AIRWORTHNESS DIRECTIVE: 103

SUBJECT: S-7 582 ENGINE MOUNT

MODELS EFFECTED: S-7 COURIER

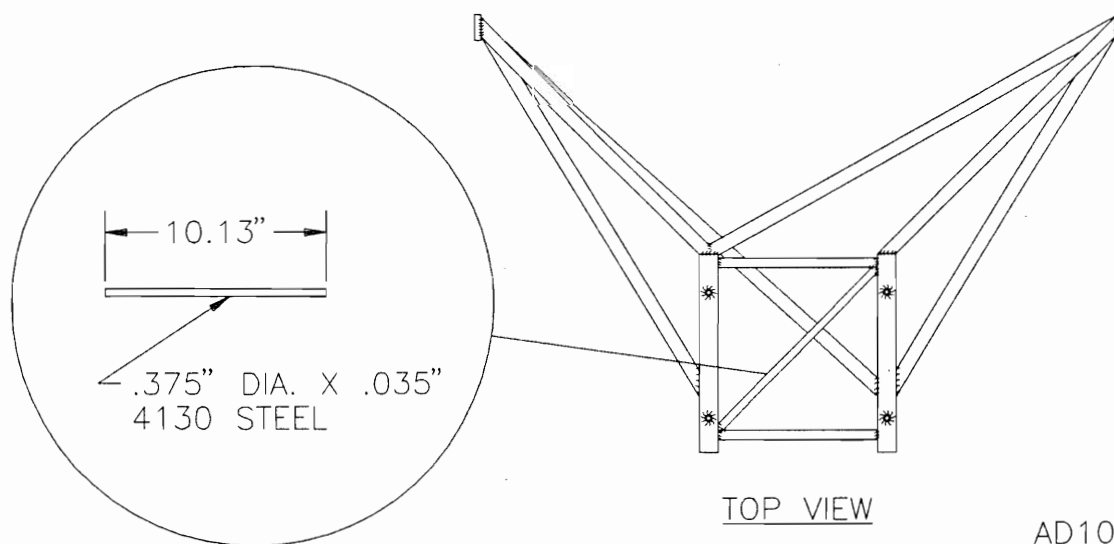
S-7 COURIER's with 582 engines must have their engine mounts inspected for cracks at the inside four corners of the engine mount bed. The engine mount may have a diagonal chromolly tube across the engine bed. if this tube is not there you must repair this with one of the three options below.

1. Trim the cromolly tubing to closely fit the inside corners diagonally.
2. Weld the tubing in place (TIG or OXY/ACETYLENE WELDING is reccomended).
3. Paint to suit.
